## GROANING NOISE FROM DOORS

This Service Information bulletin replaces SI B51 10 16 **dated June 2017**

F30 (3 Series Sedan)	F31 (3 Series Sport Wagon)	F80 (M3 Sedan)	
----------------------	----------------------------	----------------	--

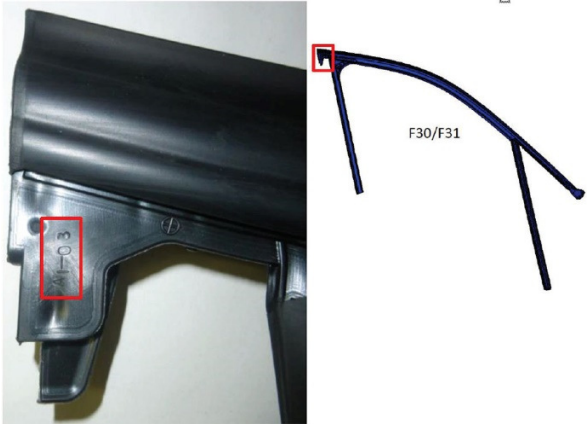
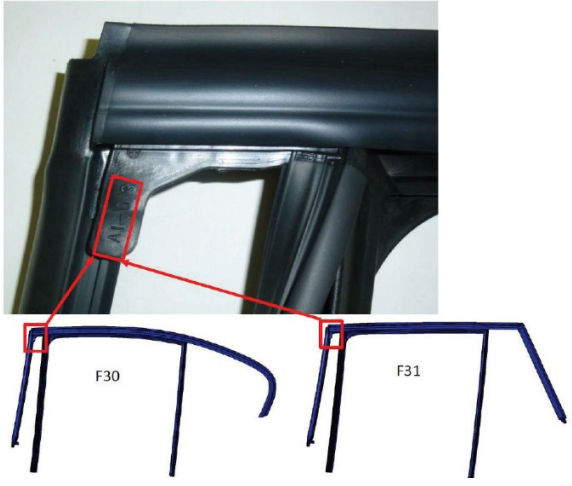
Excessive friction between window guide and door opening. Situation is worsened by:

- Option SA 760 high-gloss shadow line
- High ambient temperature
- Uneven driving surface

Replace window guides on affected doors if they are not the updated versions.
